EGG-SSDC-5381

March 1981

HUMAN FACTORS EVALUATION OF
THE ENGINEERING TEST REACTOR
CONTROL ROOM

Figure 13. Neutron-level Recorder. An indication of the normal operating range of this meter would help the operator to determine when a deviation occurs.

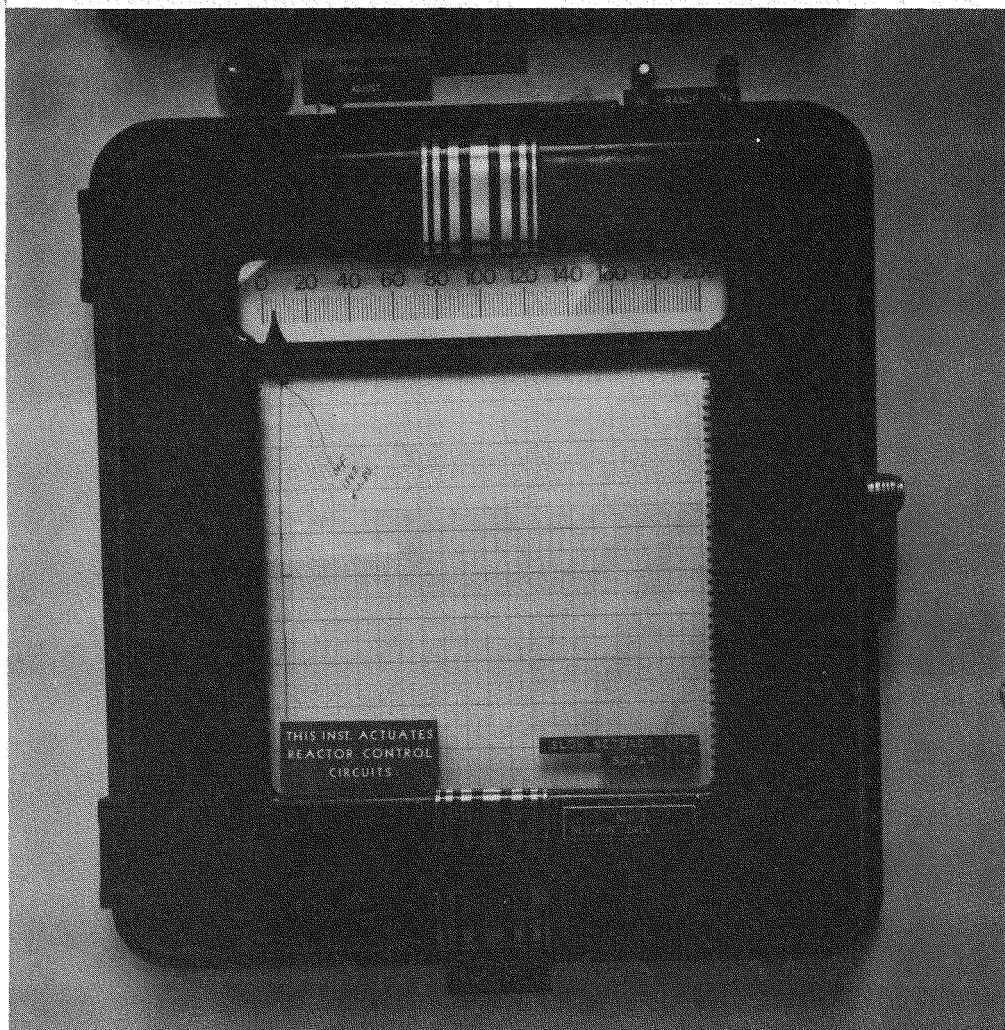
1. The strip-chart recorders e.g., neutron-level indicators, have no operating range demarcation lines on the scales to project normal system operation profile goals (see Figure 13). If the glass faces of these instruments were marked with thin red strips of tape which corresponds to $100 \pm 2\%$ power, it could substantially aid operators in identifying quickly and accurately deviation from goal profiles without mental interpolation and reliance on memory alone. As an alternative, premarked chart paper could be used.

This approach is also recommended for period recorders, TRA-4-2B, DPRA-4-3A, and DPRA-4-3B.

Figure 14. The units of measure on the Health Physics strip chart recorder RR-1A and RR-1B are written with a grease pencil and are partially obstructed by the meter cover.

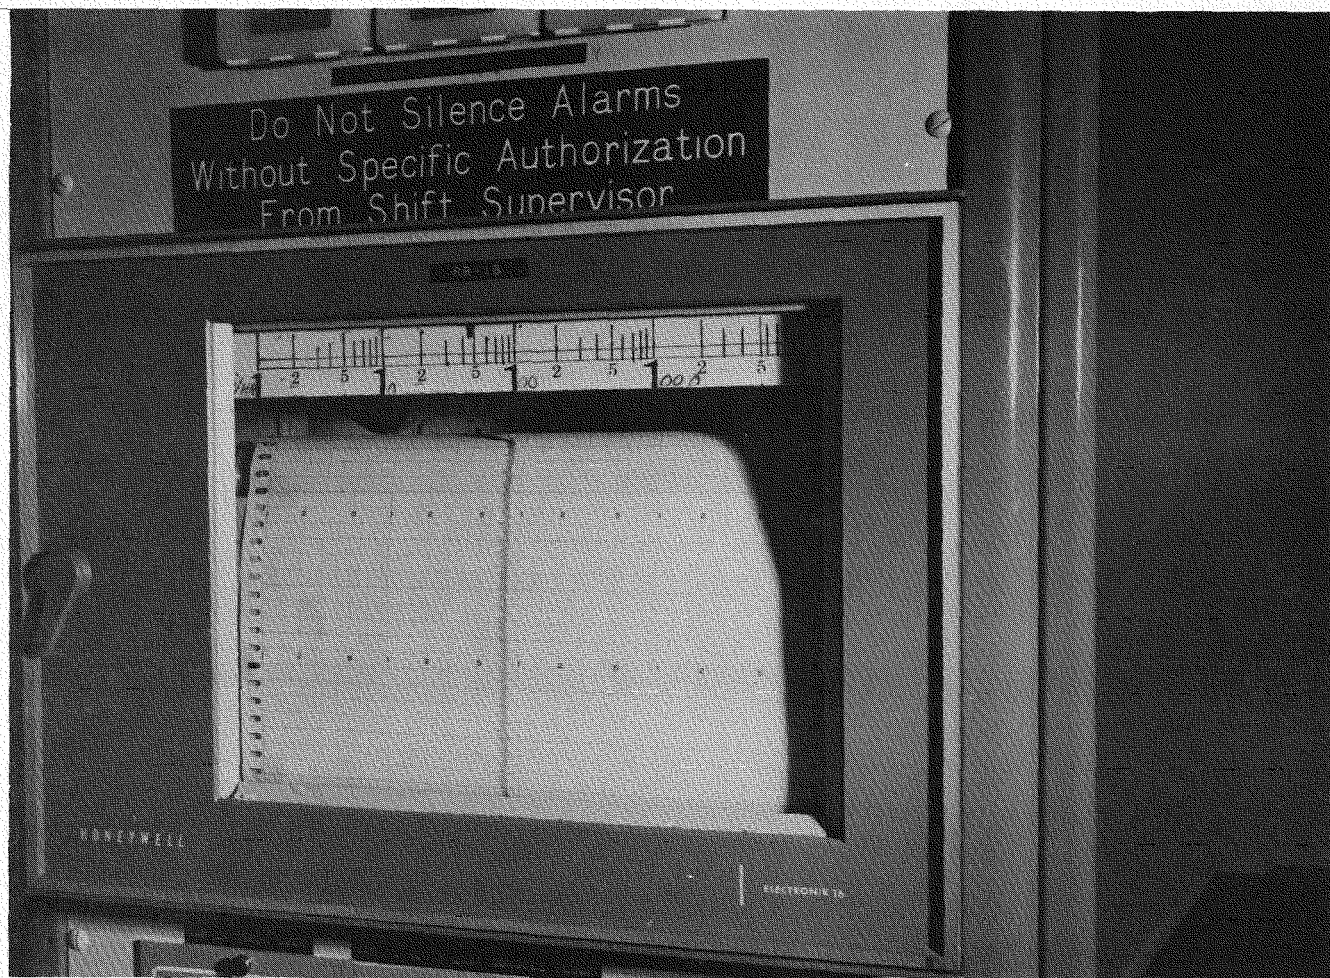
2. The units of measure for the health physics strip-chart recorders RR-1A and RR-1B were not easily discernable due to the fact that they were handwritten with a grease pencil and partially hidden from view behind the meter cover (see Figure 14). Although this condition may seem minor, it should be corrected.

In the case of the stack monitor strip chart, there was no indication as to the units of measure associated with the display. Clearly labeling the units of measure on these displays is suggested.

Figure 16. The scale graduations of PRA4-1C progress in units of 30. Scale graduations should progress by 1, 2, or 5 units or decimal multiples thereof.

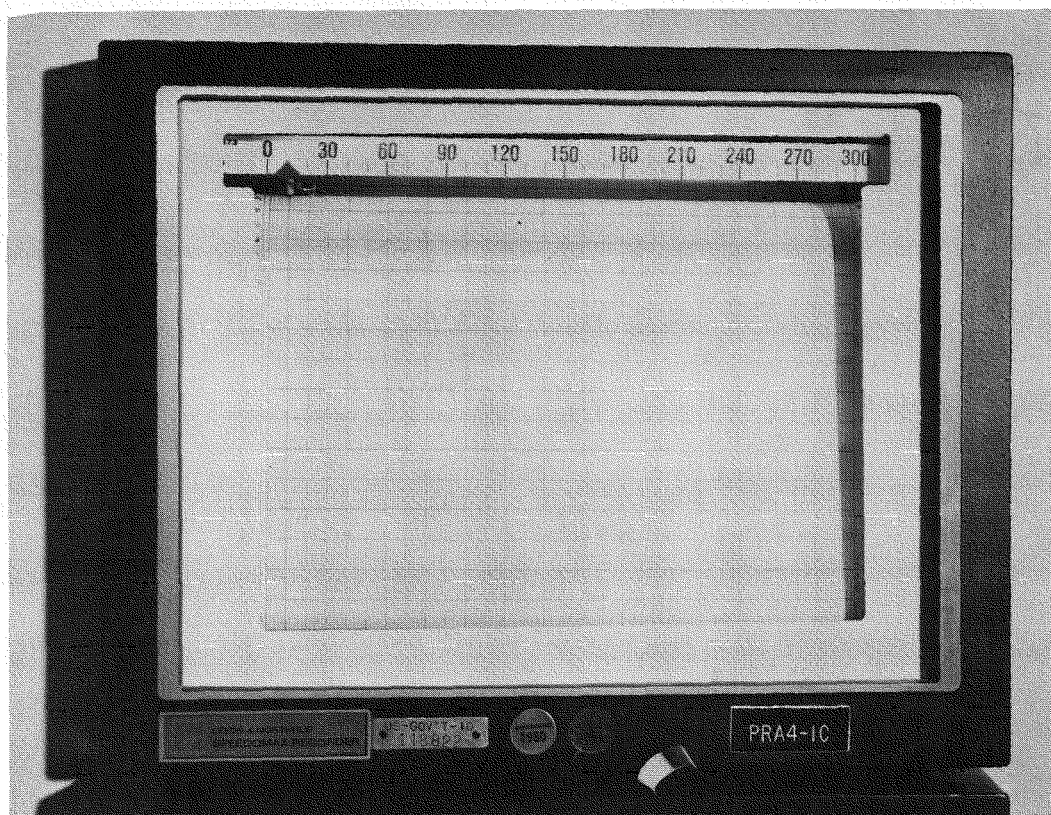
5. Scale graduations on meter PRA4-1C progress in units of 30. Therefore, it is difficult to determine accurately what numeric scale value the pointer is indicating in intermediate positions (see Figure 16). Scale graduations should progress by 1, 2, 5, or decimal multiples thereof.

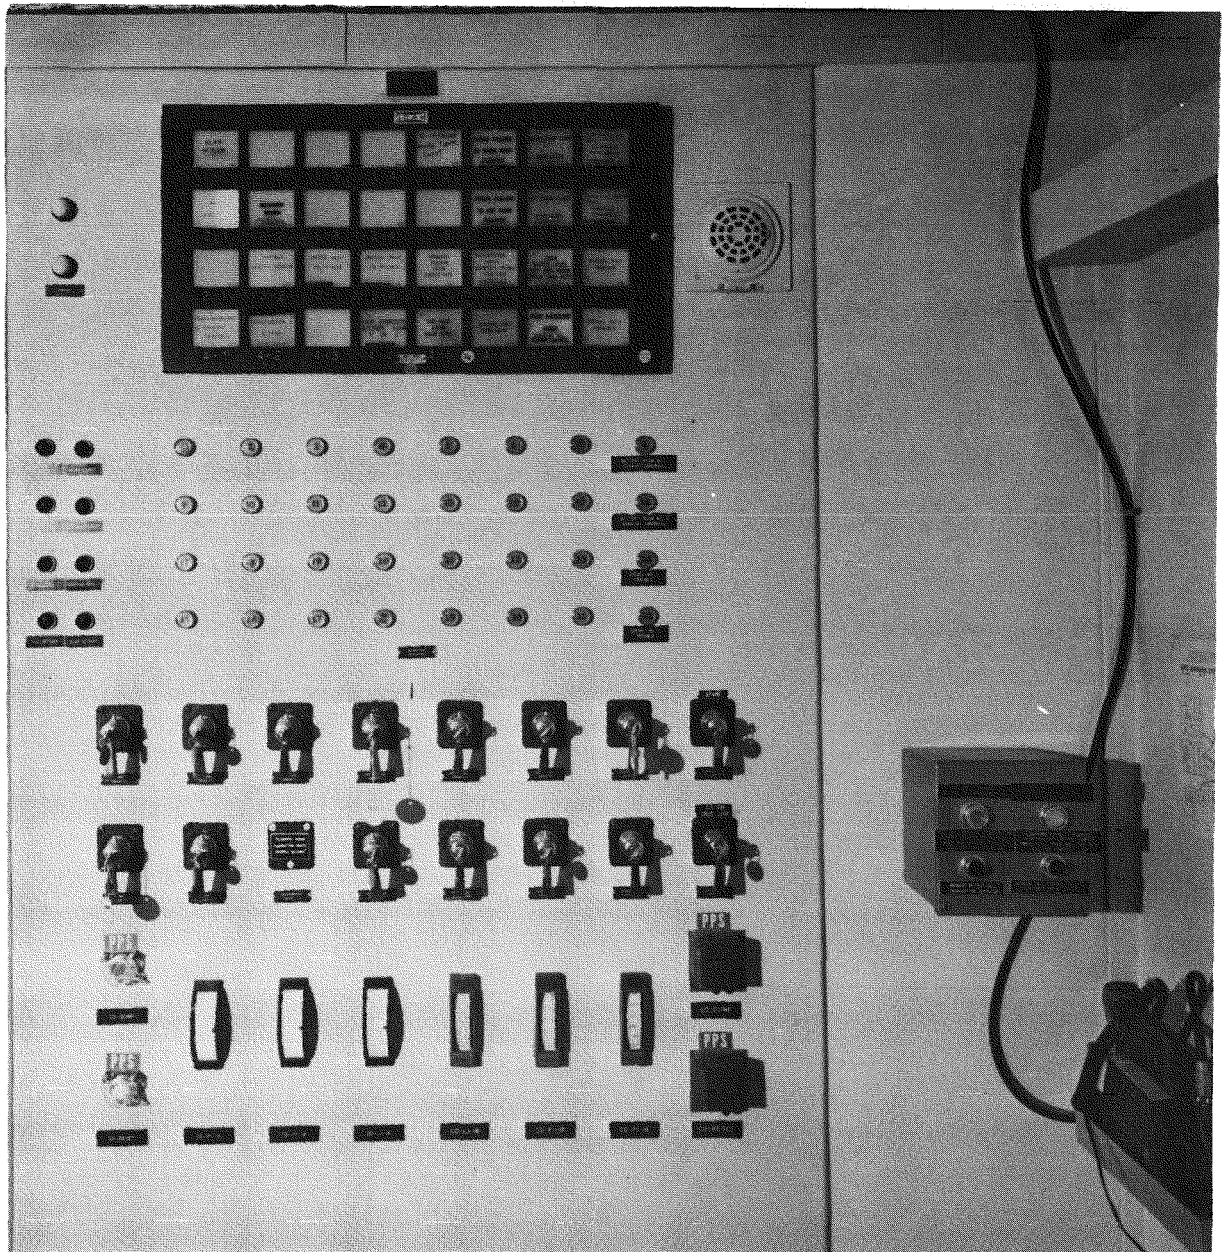
3. It was noted that 34 annunciator elements were marked with 1/4-in. red tape to indicate priority shutdown alarm conditions (see Figure 17). These

34 annunciator elements so marked were randomly scattered throughout Panel R-5, R-6, R-8, and R-10 annunciator displays.

Figure 17. Panel R-10. 1) There are 34 annunciator elements marked with red tape to indicate their importance during shutdown. It is recommended these elements be grouped together. Many of the annunciator elements are very difficult to read from the reactor console. 2) Nonfunctional water loop W switches. These controls have been nonfunctional since 1970 and should be removed.

1. In general, we found the annunciator system to have inadequate labeling relative to the criteria of rapid and accurate reading (see Figure 17). From the operator's seated position, it is difficult to read the imprinted black characters clearly. This is due partially to the fact that suboptimal height, width, stroke width, and spacing between characters was noted. In addition, poor contrast exists between the lettering and the background found on the annunciator panels. Since the annunciator panel is considered to be extremely important to the operator, the following recommendations are suggested:

The Water Loop W Switches located on Panel R-10 have not been in use since 1970, 10 years ago, (see Figure 17). It is unlikely that these controls and meters will ever be used again, primarily because the involved circuits do not conform to current standards (RDT-26T). For this reason, and also because of the potential gain of an additional 9 to 12 square feet of panel space, it is recommended that all nonfunctional equipment related to this system be physically removed from the main control room.

To improve visual access and enhance alarm identification, it is recommended that all of these priority shutdown annunciators be grouped together on one centralized display panel. This would allow the operators to quickly detect a priority shutdown alarm without the degree of visual searching currently required, and also eliminate the need for makeshift tape markings. Another drawback to the current use of red tape is that one-half of the light source on the annunciator element is red. Therefore, a red-on-red (low contrast) visual condition exists which is more difficult to visually detect than red-on-white, for example.

- o Letter width should be at least $3/5$ of the letter height, with the exception of the letter "T" which should be one-stroke width wider, and the "M" and "W" should be at least $4/5$ of the letter height.
- o Character spacing should be a minimum of one-stroke width.

Figure 18. A suggested arrangement for the seat and clutch indicator lights

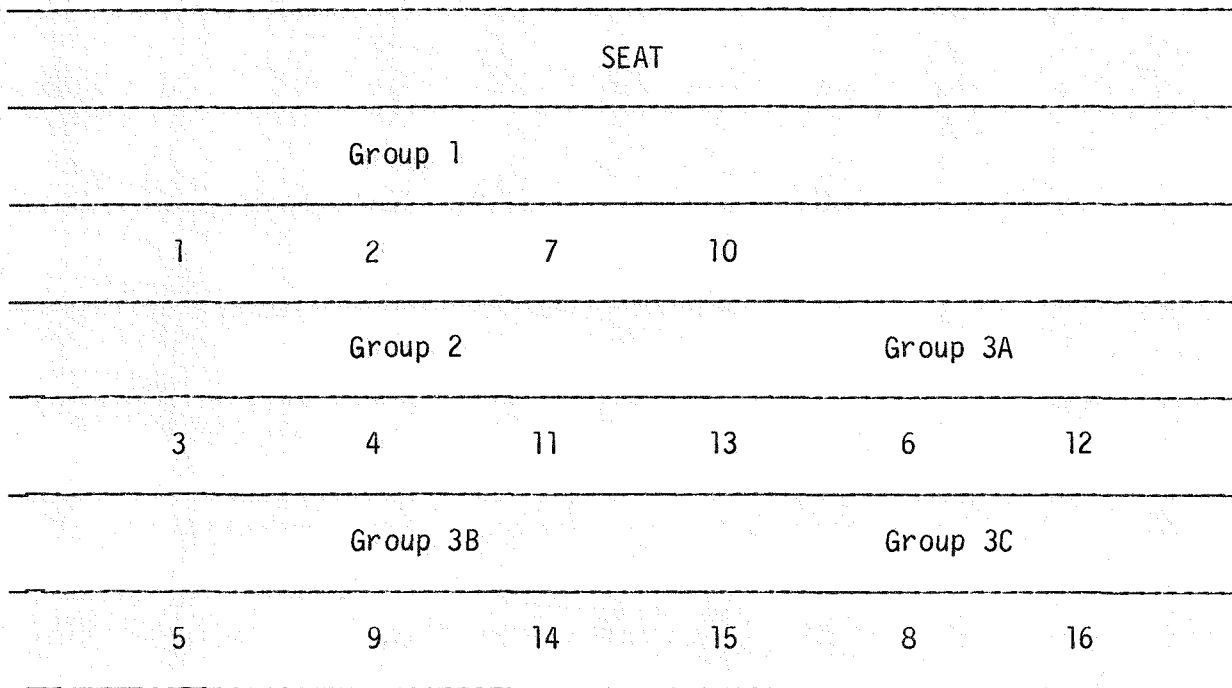
1. The seat and clutch indicator lights associated with each shim rod are very difficult to distinguish among the array of other lights on Panel R-15 and R-11. Because these lights are not used directly with either the shim-rod selector switch or the shim-rod position digital display, it is recommended that the seat-indicator lights be grouped together in one array, and that the clutch-indicator lights be grouped together in a separate array. The simple indicator lights should be converted to legend lights and be grouped in an array that mimics the arrangement of the shim rods. A suggested arrangement for the seat indicators is shown in Figure 18. A similar arrangement is recommended for the clutch lights.

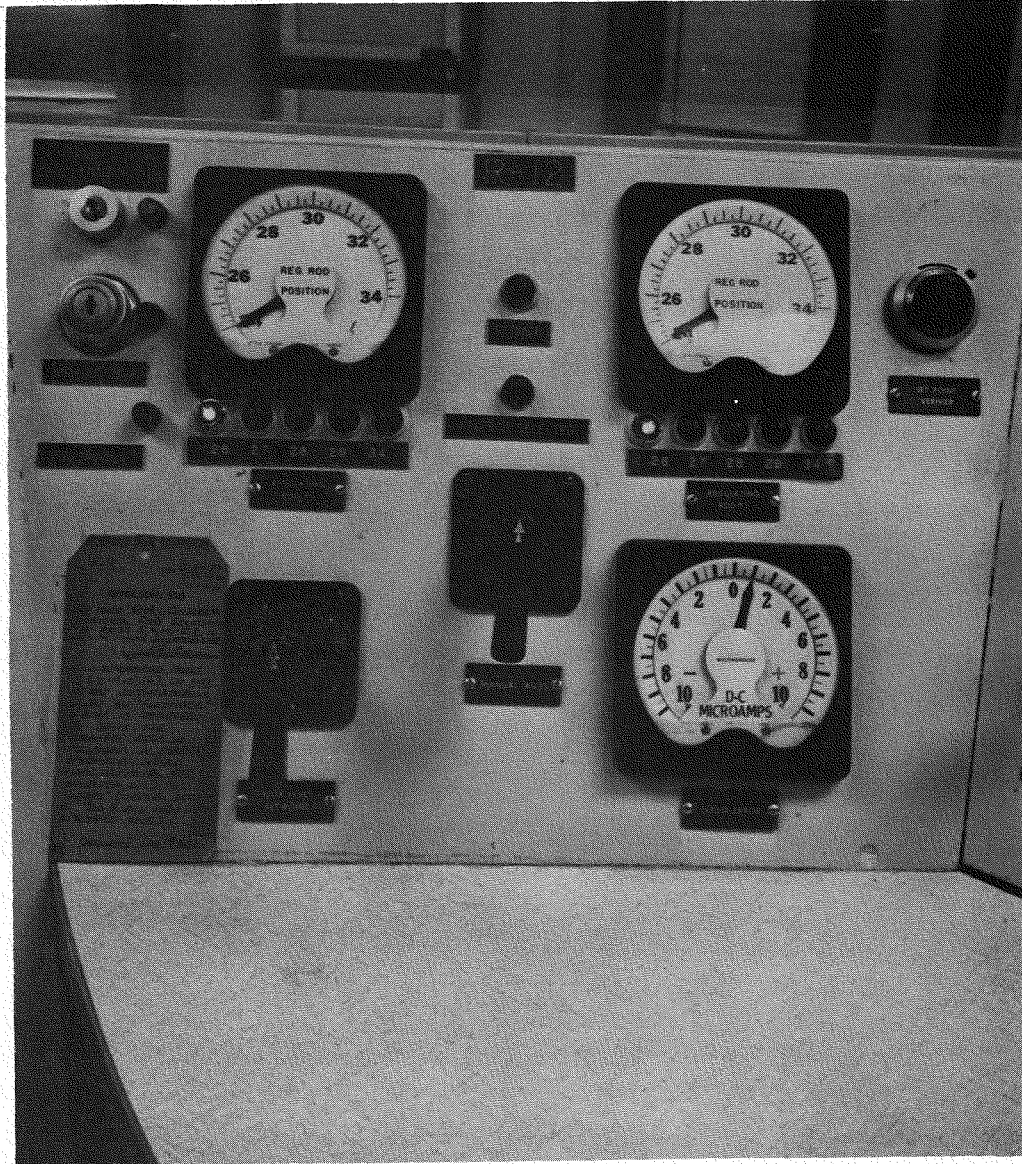
1. There are three meters which display the regulating-rod position. The fixed-scale moving pointer circular meter on Panel R-12 and the strip-chart recorder on Panel R-13 both show the position of the regulating rod in its normal operating range (see Figure 19). The digital display for shim rod No. 1 and 10 (the regulating rods) serves as a third indicator. It is recommended that the shim-rod digital displays be used as a backup indication of the regular rod position, and the fixed-scale moving pointer displays be eliminated from the panel. An indication of the "percentage pile power" and a digital display of the water power could be substituted for these two meters.

2. The pointer on the servo indicator located on Panel R-12 can cover the numeral value it is pointing to. This is also true for the regulating-rod meters No. 1 and 2, also located on the reactor control console (R-12). Pointers should not obscure the numerals and scales on the meter face.

Figure 19. Panel R-12. 1) The two regulating rod-position indicators, "A", and "B" can be eliminated from the panel. There are two other meters which show the same information. 2) The simple indicator lights, "C", which warn the operator when the regulating rod position is out of the operating range should be replaced by legend lights.

The regulating-rod position indicator lights currently placed directly beneath the regulating-rod position markers on Panel R-12 correspond to a number of reactor set points and enable switches (see Figure 19). The indicator lights are named, color coded, and used to mean the following:

It is recommended that the simple indicator lights be replaced with legend lights that are color coded and labeled as follows:

<u>Recommended Label Name</u>	<u>Recommended Color of Lights</u>
34-Upper Limit	Amber
29-Withdrawal Inhibit	Red
28-Preferred Insert	Red
27-Rundown	Red
26-Servo-Limit Position	Red

Figure 20. Annunciator Acknowledge and Test Buttons. Note height and location. These items should be repositioned.

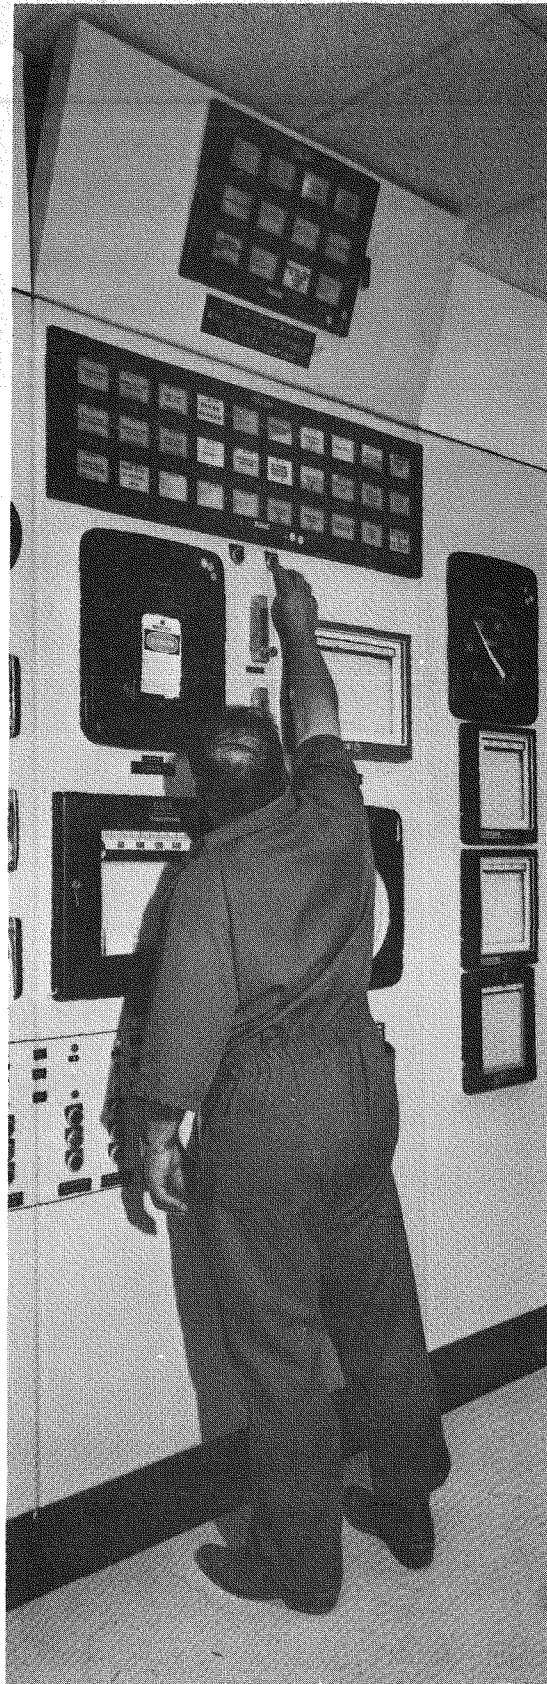
1. The annunciator acknowledge and test buttons were located too high and distant from the operators' central desk in the Process Control Room (see Figure 20). These buttons were not positioned appropriately in relationship to their relatively high frequency of use by the operators. It is suggested that all bulkhead-positioned annunciator acknowledge and test buttons be mounted on a unit which can be operated from the operators' desk. This should improve ease of access and reduce the level of irritation currently associated with these controls.

Figure 21. Core deluge annunciator acknowledge control. Access blocked by permanent blackboard which precludes direct visual and hand access.

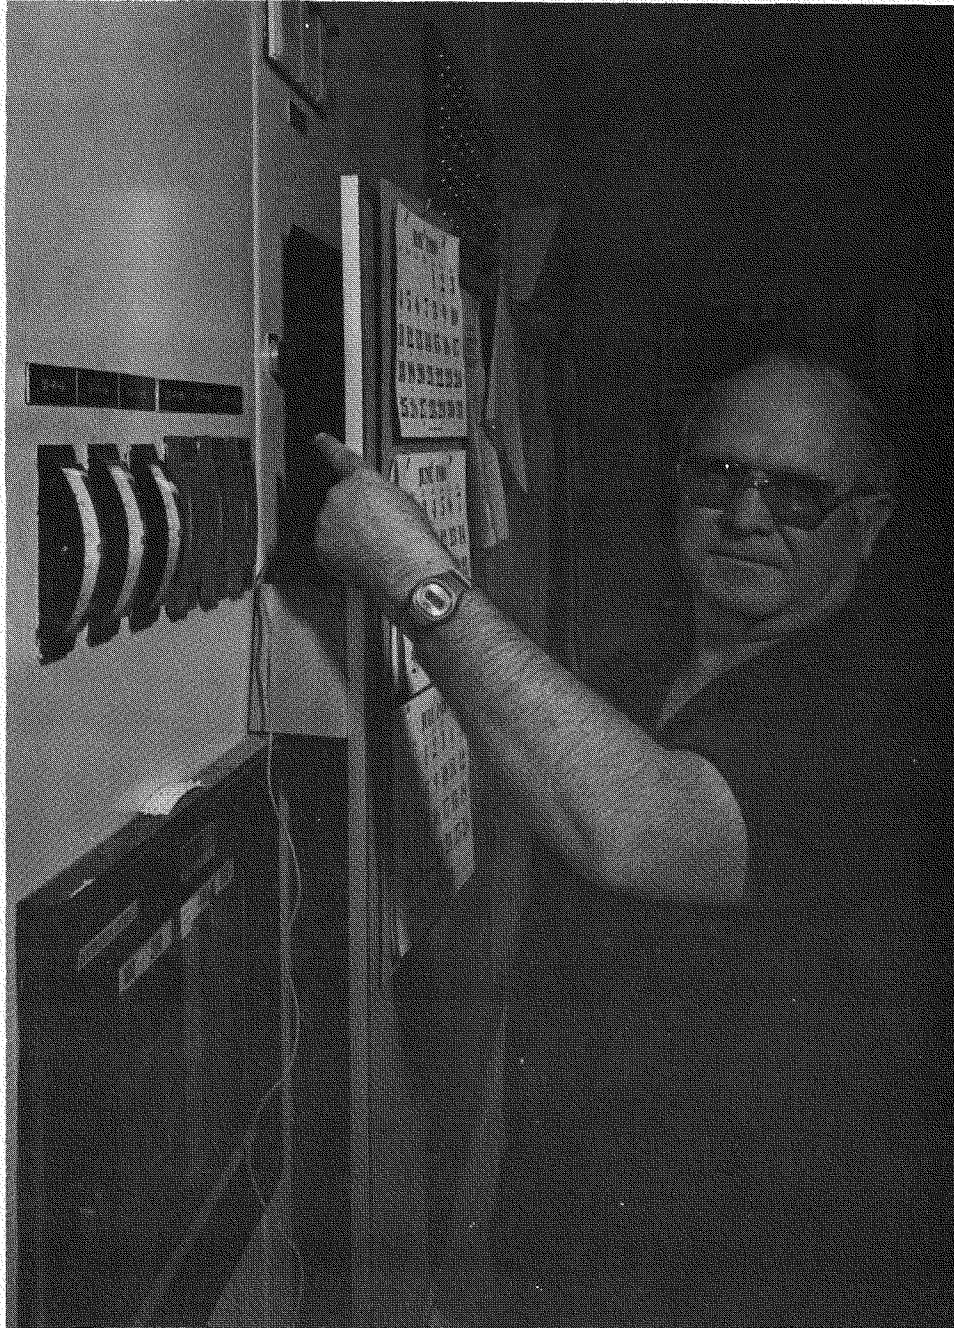
3. The core-deluge annunciator acknowledge and reset buttons are not in plain view, but are covered by a blackboard (see Figure 21). To access these buttons, one must reach around behind the blackboard and it is difficult to see what you are activating. These buttons should be relocated to the PCOs desk if the blackboard is not removed.
